LOCAL HISTORIC DISTRICT: Plaza Midwood

PROPERTY ADDRESS: 1608 Mimosa Avenue

SUMMARY OF REQUEST: Detached accessory building

Charlotte Historic District Commission Case 2018-526
HISTORIC DISTRICT: PLAZA MIDWOOD
ACCESSORY STRUCTURE

$$\frac{3}{A-2} \text{ Side Elevation} \quad | / 4'' = |' - 0''$$

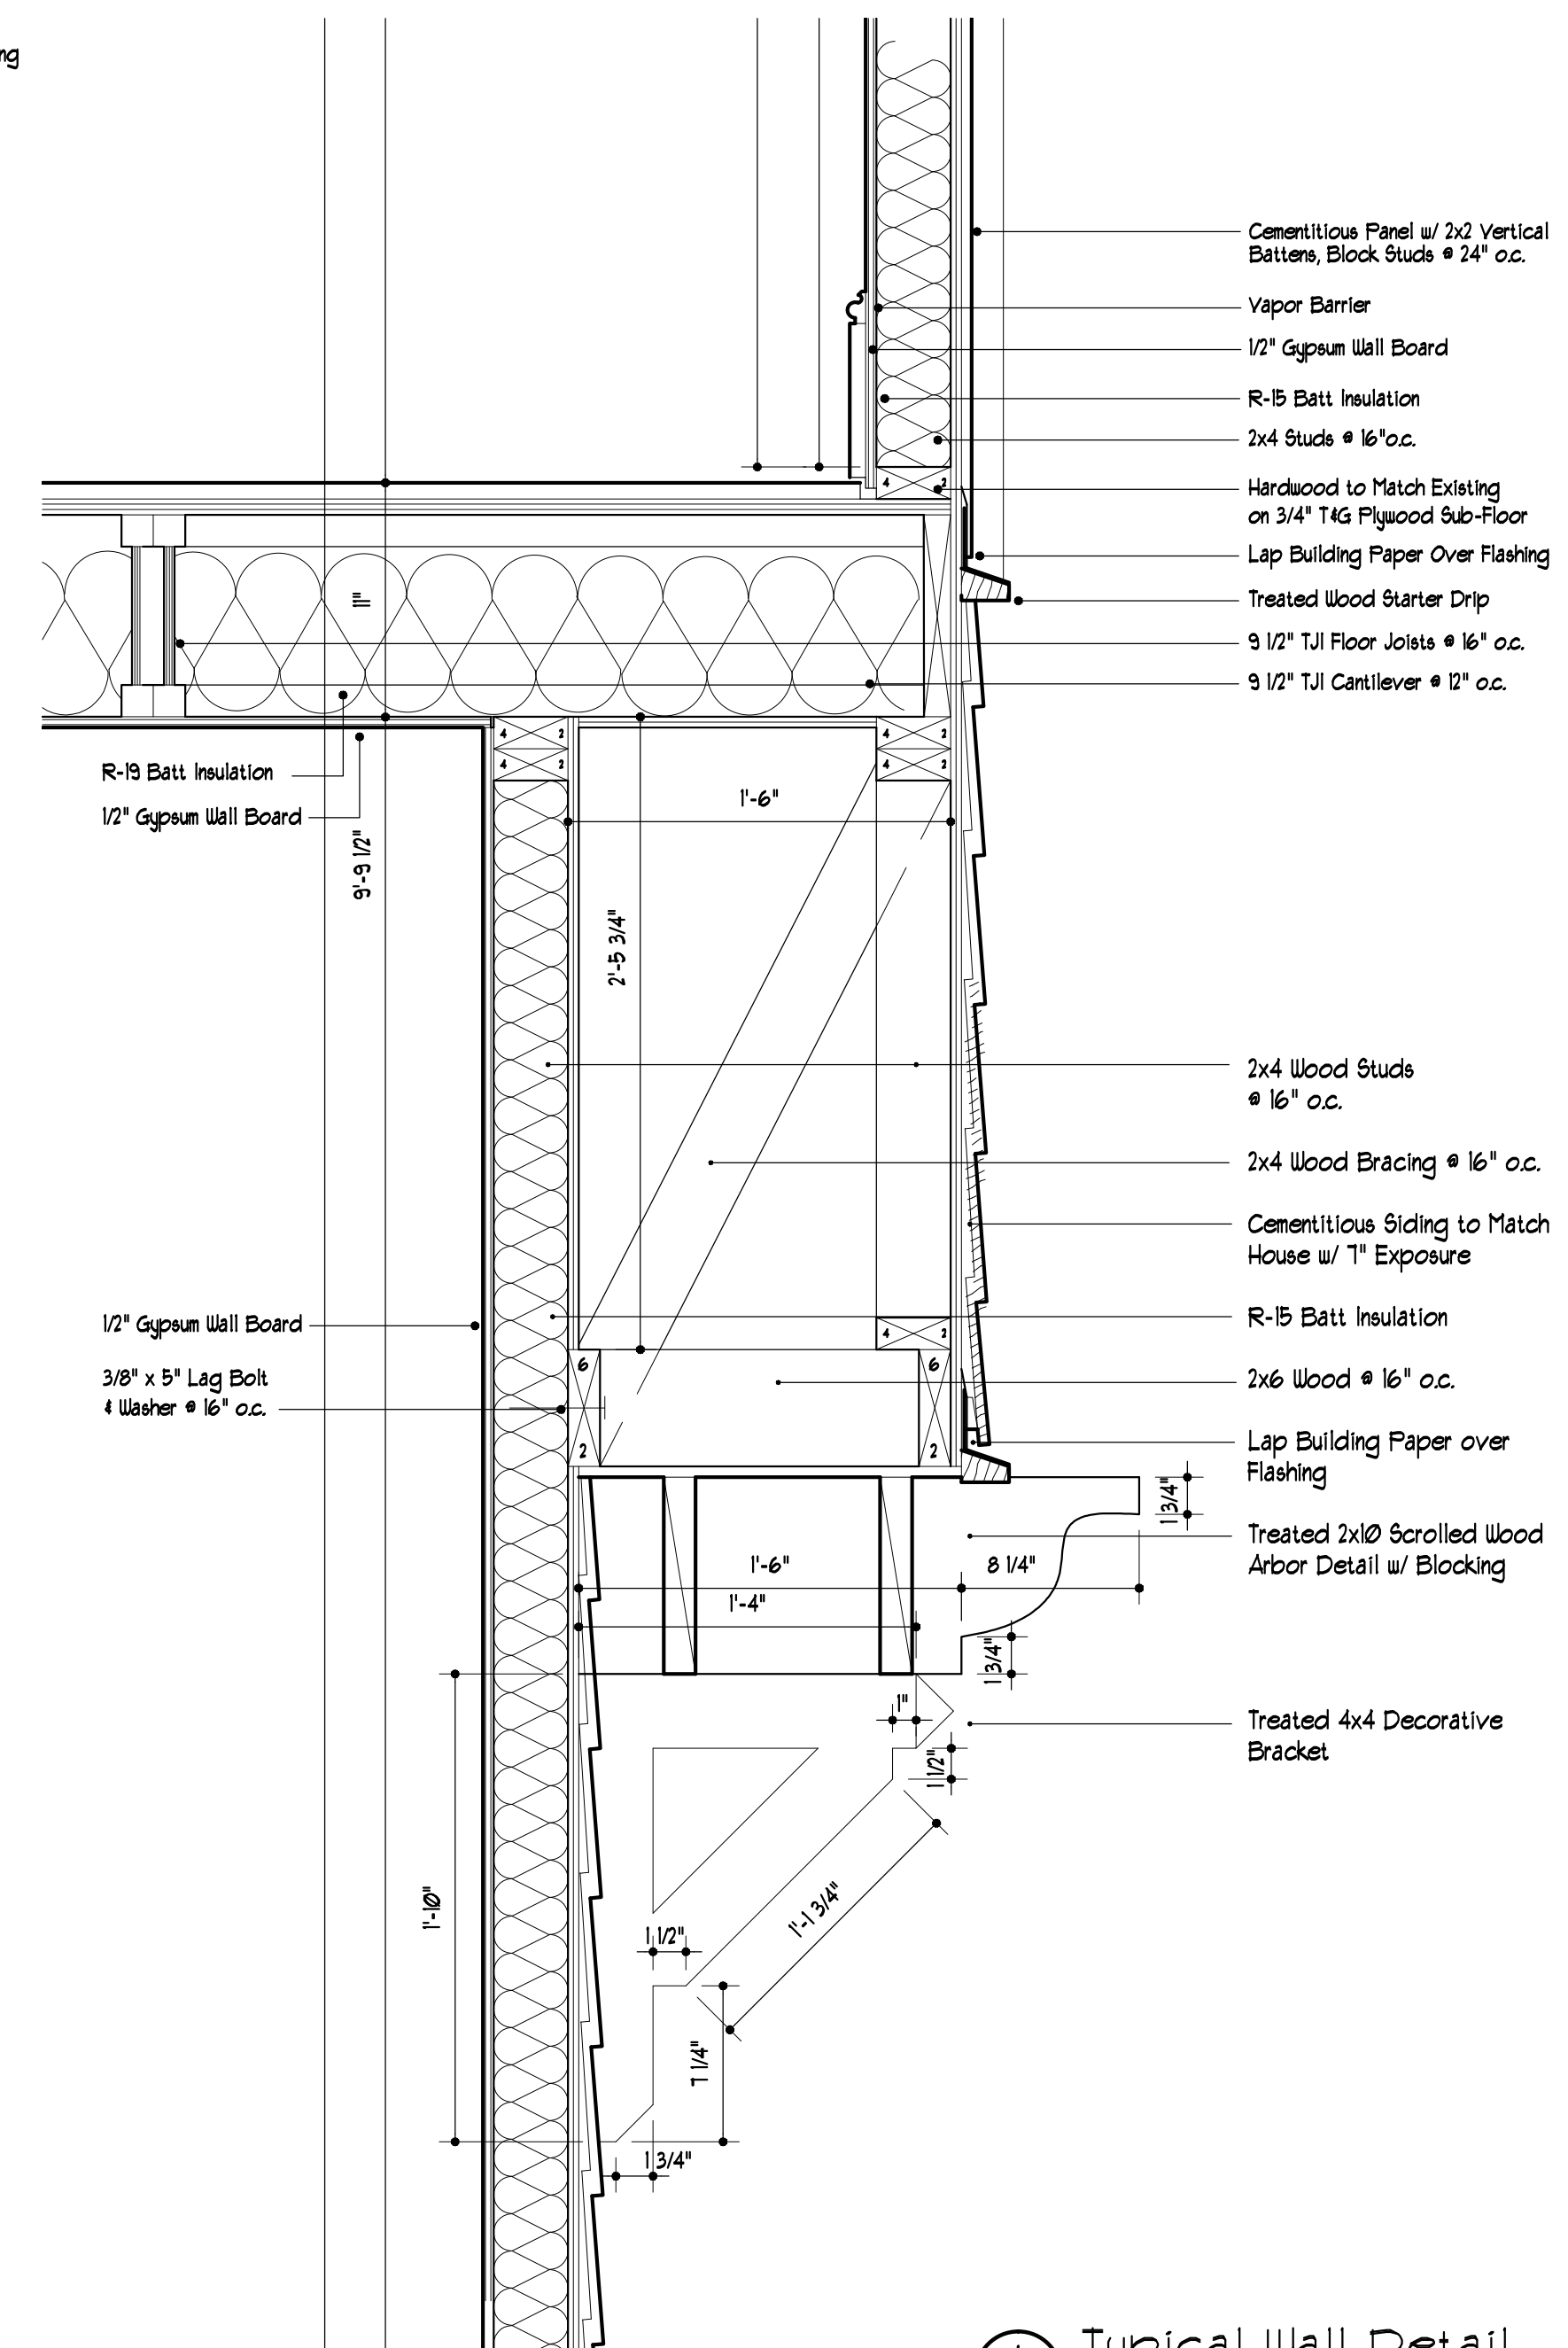
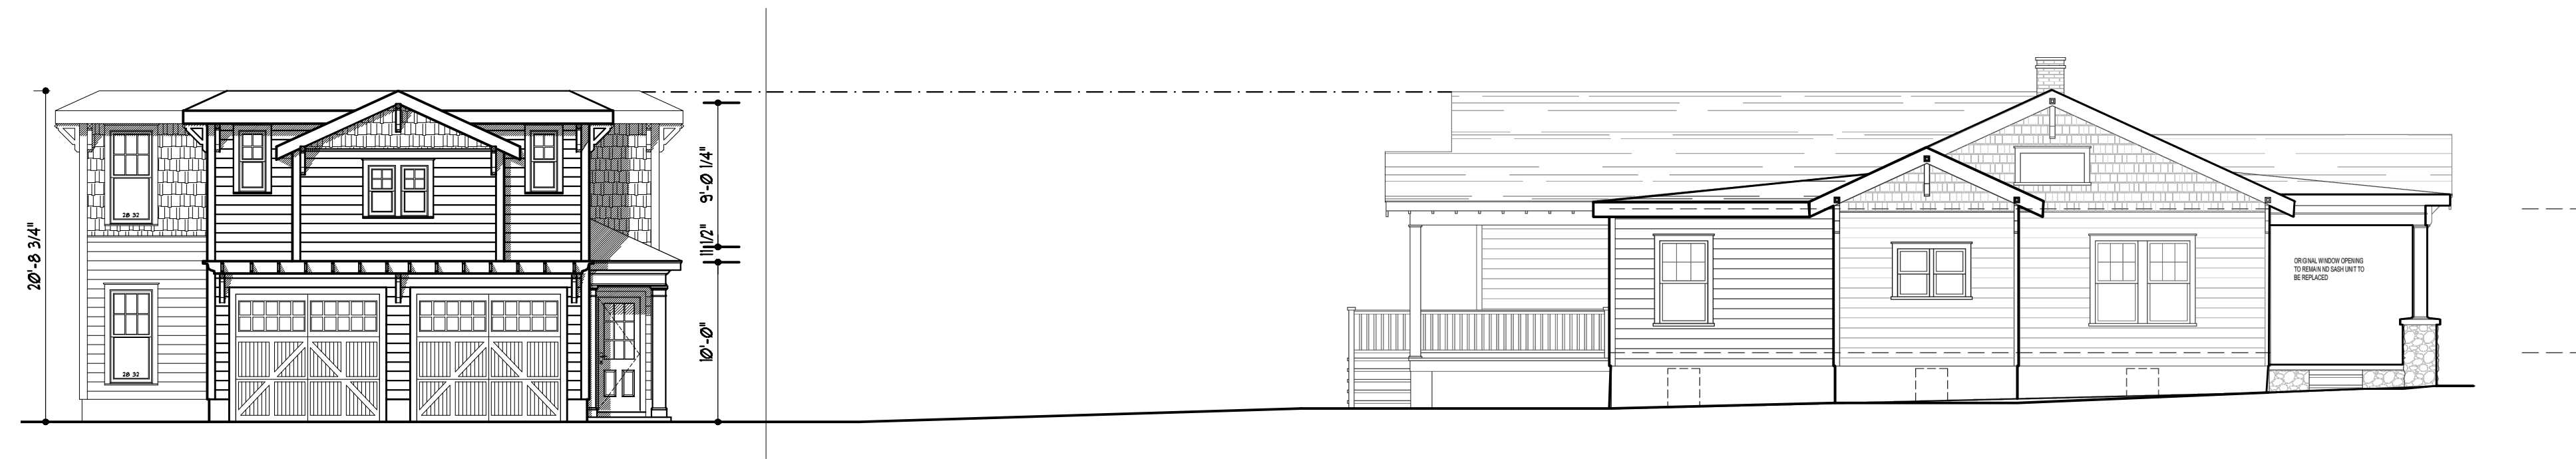
1. The gable roof element over the garage doors, use of lap and shake siding, wood doors, wood or clad windows in a 6/1 pattern, and other decorative elements such as corner boards and brackets, are compatible with the character of the primary building.
2. The Commission will determine if the ADU is secondary to the main structure.
3. Minor revisions may be reviewed by staff.
